Item Name: Aft Crosstube - High 407

Draw Nbr	Revision Nbr
D407-667-245	Rev F/DEO

DRAWING NO. D407-667-245	TITLE CROSSTUBE ASSY (407 HIGH AFT)	REV. F	DART AEROSPACE LTD ENGINEERING ORDER		D.E.O. NO. D407-667-245-F-1	SHEET NO. SHEET 1 OF 2	SCALE NTS
DRAWN	CHECKED	MFG. APPR.	APPROVED	DE APPR.			
DATE 11.04.08	DATE 11.04.12	DATE 11.04.12	DATE 11.04.12	DATE 11.04.12	DATE 11.04.12

DRAWING NO. D407-667-245	TITLE CROSSTUBE ASS'Y (407 HIGH AFT)	REV. F	DART AEROSPACE LTD ENGINEERING ORDER		D.E.O. NO. D407-667-245-F-2	SHEET NO. SHEET 1 OF 1	SCALE NTS
DRAWN 97	CHECKED ASS	MFG. APPR. E	APPROVED MP		DE APPR. TH		
DATE 11.09.07	DATE 11.09.19	DATE 11.09.19	DATE 11.09.19		DATE 11.09.19

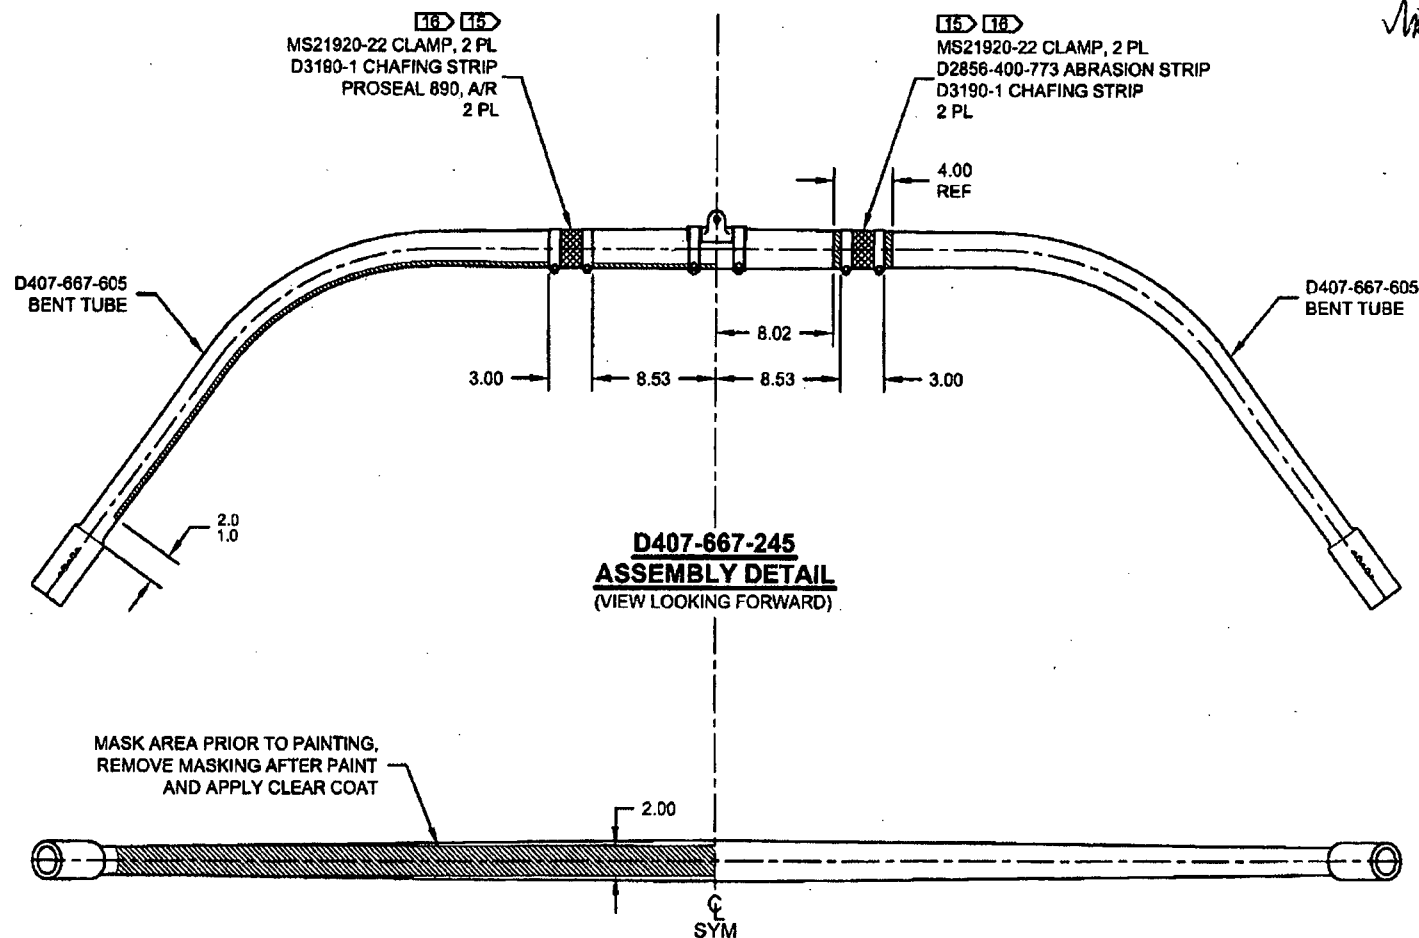
NOTES 2 AND 15, SHEET 1 ARE AMENDED AS FOLLOWS:

- 2) FINISH: CHEMICAL CONVERSION COAT PER DART QSI 005 4.1
PRIME INSIDE AND OUTSIDE PER DART QSI 005 4.2
MASK UNDERSIDE OF CROSSTUBE AS SHOWN (HATCHED AREA) AND
PAINT OUTSIDE PER DART QSI 005 4.2
REMOVE MASKING AND APPLY CLEAR COAT
- 15) APPLY A THIN COAT OF PROSEAL 890 ON INSIDE CONCAVE SURFACE OF D3190-1
CHAFING SHIELDS AND LET CURE PER MANUFACTURER'S INSTRUCTIONS. INSTALL
PROSEALED D3190-1 CHAFING SHIELDS ONTO CROSSTUBE BY APPLYING A THIN COAT
OF PROSEAL 890 ONTO CROSSTUBE. BE SURE TO ELIMINATE ANY AIR GAPS.
